**Subject: 25.903e Response**

Ref. 991116/16 - 25.903(e) Inflight Starting  
Attachment 10

**Subject:** Minority Position on Proposed AC 25.903 e)

CHART 2  
Commercial Transport Fleet All-Engine Power Loss Events, by Flight Phase  
1960-1996

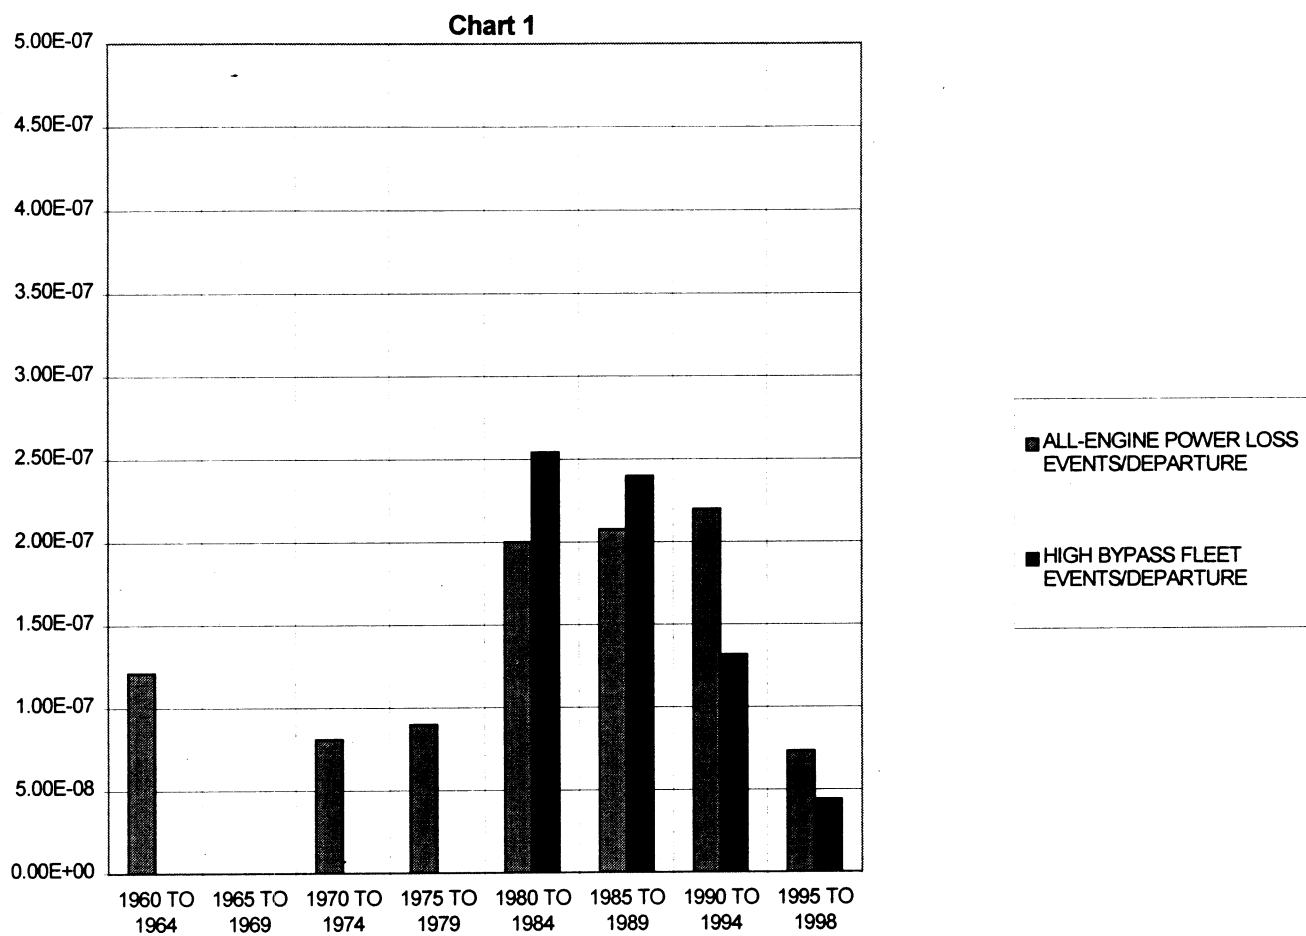
The flight conditions specified in the AC do not reflect the flight conditions at which the majority of all-engine power losses have historically occurred, according to this database. Specifically, condition 4 (low power, below 10,000 ft, 1.45 V<sub>stall</sub>) reflects a more severe condition than has been documented for an all-engine power loss in the commercial transport fleet. It is proposed that the requirement of section 7, condition 4, for an initial airspeed of 1.45 V<sub>stall</sub> be changed to permit a higher initial airspeed such as 250 kts.

Majority of events occur at high/intermediate altitudes.  
Low altitude/low airspeed/low power scenario (condition 4)  
represents no events/ a very small proportion of events

Chart 3  
Certified Windmill Start Envelopes

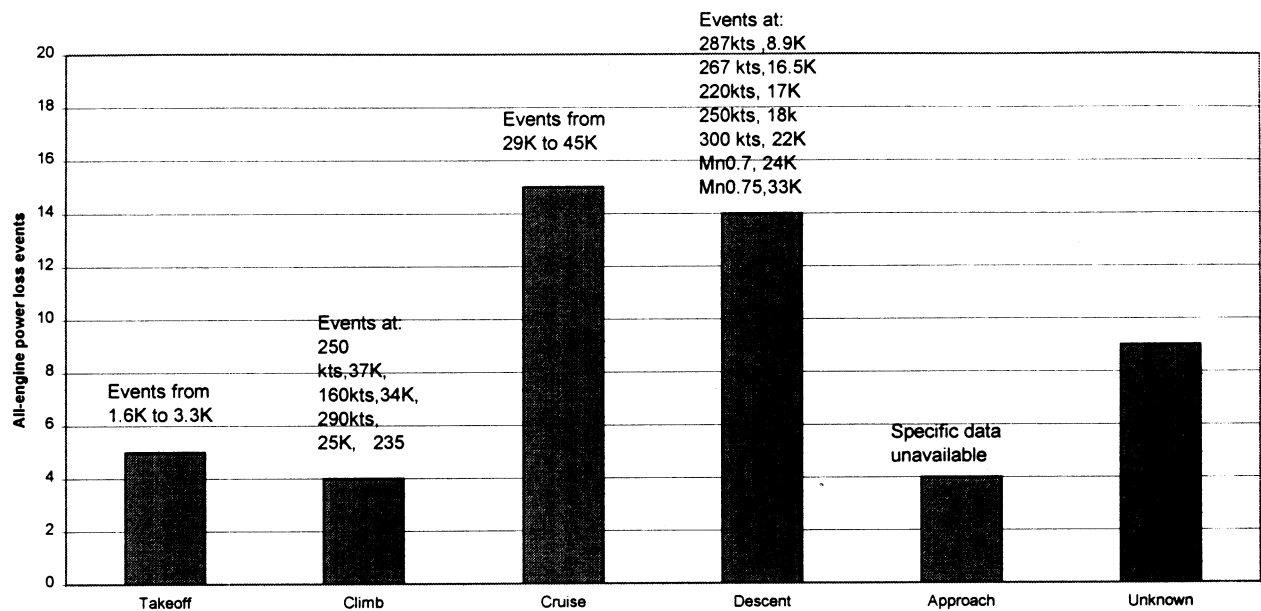
Chart 3 shows the minimum windmill start airspeed as a function of aircraft certification date. Half of the engine/airframe combinations currently in service are capable of windmill start, S/L, at 250 knots. Therefore a reasonable criterion for maintaining the current safety standard would be 250 knots rather than 1.45 V<sub>stall</sub>. The following wording change is proposed to Section 7, condition 4:

The initial airplane speed that should be used for the all-engine out restart evaluation is **250 kts**. Acceptable means of compliance include rapid relight, starter assistance from an external source and stabilized windmill start. The airplane should not lose more than 5000 feet altitude between initiating restart procedures and achieving level flight.
